Technical Service Information

VOLVO AW55-50SN NEUTRAL BANG ON TAKE-OFF

07-25
Page 1 of 1

Figure 1

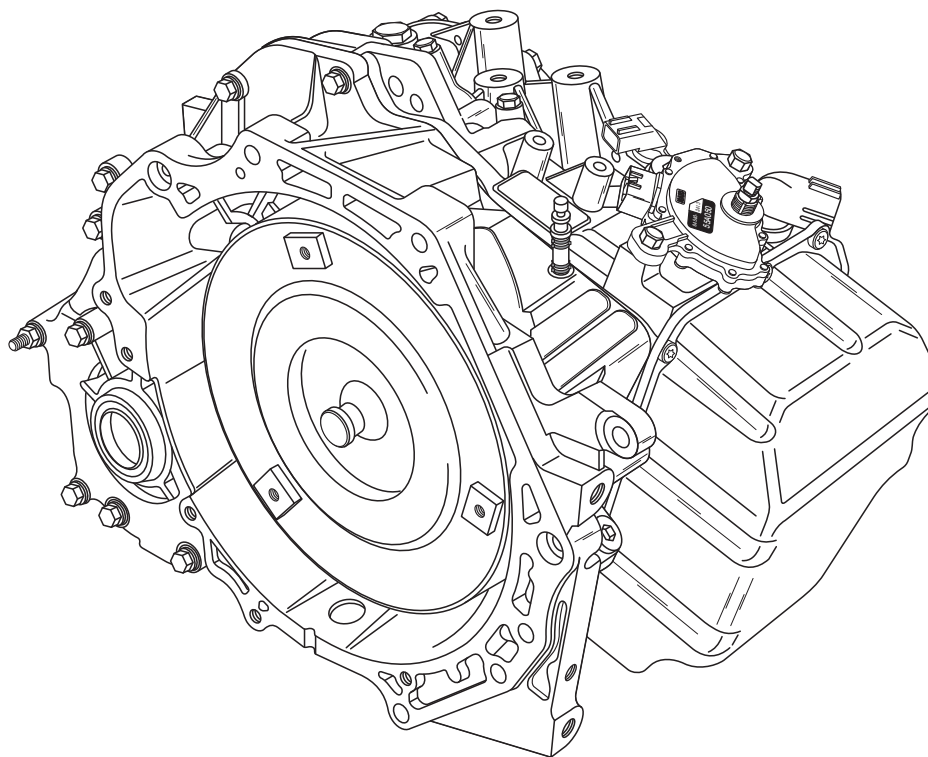
COMPLAINT: Some Volvo models equipped with the AW 55-50 SN transaxle, as shown in Figure 1, may exhibit a neutral bang on take-off before or after overhaul.

CAUSE: The cause may be, that when the accelerator pedal is depressed rapidly, the customer may feel a re-engagement of the C1 clutch on take-off because of a Transmission Control Module software issue.

CORRECTION: To correct this complaint, the TCM will have to be reflashed by a Volvo dealer, which will deactivate or de-sensitize this feature. TCM 012B Neutral Control Flash.

TCM UPGRADE NUMBER (Volvo).....30677036
